To: Nunavut Water Board  
From: Baffinland Iron Mines Corporation  
Title: **2024 NWB/QIA Annual Report for Operations Intervenor Comments**  
Date: October 2, 2025

## **2024 NWB QIA ANNUAL REPORT FOR OPERATIONS – INTERVENOR COMMENTS**

Table A.1: Status of QIA Comments on Baffinland’s 2024 QIA-NWB Annual Report for Operations

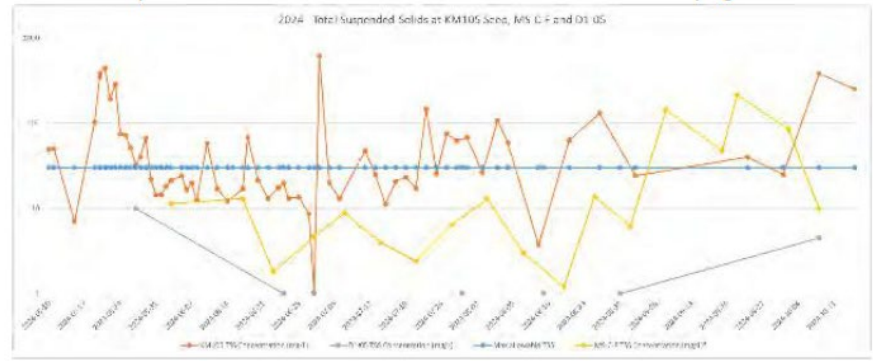
33	AE#17	<i>"Additional site visits are recommended throughout future seasons to verify the operation of data loggers and perform flow measurements. It is recommended that future hydrometric monitoring continue to target low flow and/or high flow periods to maintain and further validate the rating relationships. Peak flows tend to occur in the spring but not always when the channels are ice-free"</i>	QIA supports the recommendations for additional hydrometric site visits throughout future seasons to verify the operation of data loggers and perform flow measurements and	This comment is a repetition of comments in other regulatory forum, and as such, Baffinland considers this comment complete for the purposes of this report. In addition, comments about management plans belong with the review process for the respective management plan. Please refer to the attached Table 1 for more details.

No.	Intervener Cmt. No.	Intervener Comment	Intervener Recommendation	Baffinland's Response
		<p>or when conditions permit safe access for gauging. Following the extreme rainfall observed in September 2024, peak flows that occur in summer and fall months continue to be a good to target. In future programs, if they occur, precipitation events of greater than 4 mm per day should continue to be noted as they typically result in an appreciable increase in flow, especially at the stations with smaller catchments. Precipitation events that last for more than one day, with cumulative precipitation over 10 mm, can result in much higher flow, especially earlier in the summer (mid-July to mid-August) before the active layer of permafrost fully develops." (App. E.9.3, s.6, p. 8)</p> <p>Monitoring of stream flow through the open water season is important for understanding Arctic char access to and from juvenile summering habitats upstream of the Tote Road crossings, and to inform the design of culvert stream crossings.</p>	continued targeting of low flow and/or high flow periods--particularly extreme peak flow, to maintain and further validate the rating relationships.

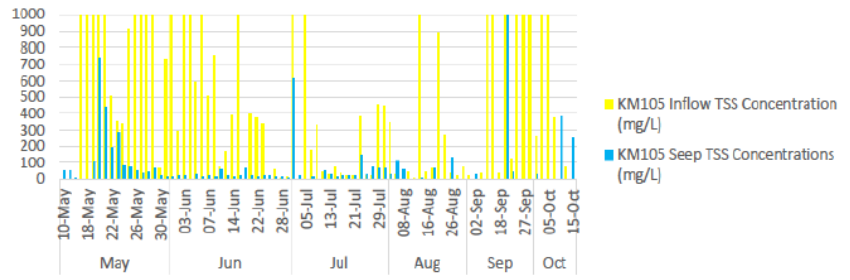
34	AE#18	<p>Baffinland reported on the September 2024 extreme rainfall event as follows: "During this event, TSS at the seep reached 9040 mg/L but dropped significantly in the subsequent sampling on September 24, where it was 40 mg/L. Suspended solids concentrations at receiving environment assessment station D1-05 on September 20 and on October 8 when the subsequent sample was collected remained very low at 2.8 mg/L and 4.5 mg/L, respectively, assessing negligible impact to the receiving environment fish bearing habitat as a result of the seepage even during the unprecedented 1:1000 rainfall event." (Appendix E.8.2 (Part 1 of 2), p. 54). What biological data does Baffinland have to support this conclusion?</p> <p>The following footnotes appear beneath Figure 3. "Total Suspended Solids at the KM105-Seep and Downstream Stations MS-C-F and D1-05" on page 55:</p>  <p>"Logarithmic scale used due to the wide range of TSS values, particularly the TSS value measured during the September precipitation event. And, Outlier data for KM105 TSS concentration on September 20 of 9040 mg/L removed from figure dataset." These changes fundamentally alter the figure by damping the apparent variability.</p>	<p>QIA requests Baffinland:</p> <ul style="list-style-type: none"><li>identify the biological data used to support its conclusion there was no impact from the high TSS pulse,</li><li>provide figures for the KM 105 seep that depict the full linear range of TSS measurements, and</li><li>explain why TSS concentrations above 1000 mg/L were omitted from Figure 4, and how this affects trend analysis.</li></ul>	<p>a) No biological data was collected due to the emergency nature of the 1-1000 year occurrence. As previously communicated, Baffinland's priority was re-establishing fish bearing culverts along the tote road to allow fish passage, repairing the tote road itself in order to restore essential services to cut off staff on the Project, and collecting water quality samples when safe to do so due to the hazardous weather conditions that prevailed.</p> <p>b) Logarithmic scales allow the data to be visualized more effectively and allow for comparison to low TSS results within downgradient receiving environments.</p> <p>c) Influent sample results which included the omitted values that exceeded 1000mg/L, were provided in Appendix B of the aforementioned document. The decision to truncate the values sourced from the outlier data being difficult to align with the axis scale. Conclusions from the figure that seep data was significantly lower than influent data was not impacted.</p>

No.	Intervener Cmt. No.	Intervener Comment	Intervener Recommendation	Baffinland's Response
		<p><b>Total Suspended Solids at KM105 Inflow and Seep</b></p>  <p>Figure 4: “Total Suspended Solids at KM 105 Pond Inflow and Seep” on page 57 has the following note underneath:  <i>“Note: Values that exceed the Y-axis for inflows are truncated for trend analysis.”</i></p>		
<b>Fish and Fish Habitat (FFH)</b>				
35	FFH#1	<p>QIA-6 indicated that concerns with culvert crossing inhibiting fish passage in low flows at KM33 needed to be addressed. Baffinland’s response stated that they were working with DFO during on-site inspections, and that rip rap that could potentially impact fish passage in low flows had been removed. Baffinland committed to reporting on fish passage in the 2024 NWB QIA Annual Report for Operations.</p> <p>However, QIA’s concern was primarily regarding fish strandings on areas placed above grade (i.e., the culverts installed at KM33). Baffinland’s response did not indicate that any work had been conducted/planned to address the grade of these culverts.</p>	Please provide a summary of additional plans for preventing fish strandings at above-grade culverts. Additionally, please provide a copy in the 2025 NWB QIA Annual Report for Operations, for third-party review, to ensure that rip rap removal was successful, and if additional work for improving fish passage had been committed to.	This comment extends beyond the scope of annual reporting requirements under Schedule B, the Water Licence and Section 6.4 of the Commercial Lease Agreement. Please refer to the attached Table 1 for more details.
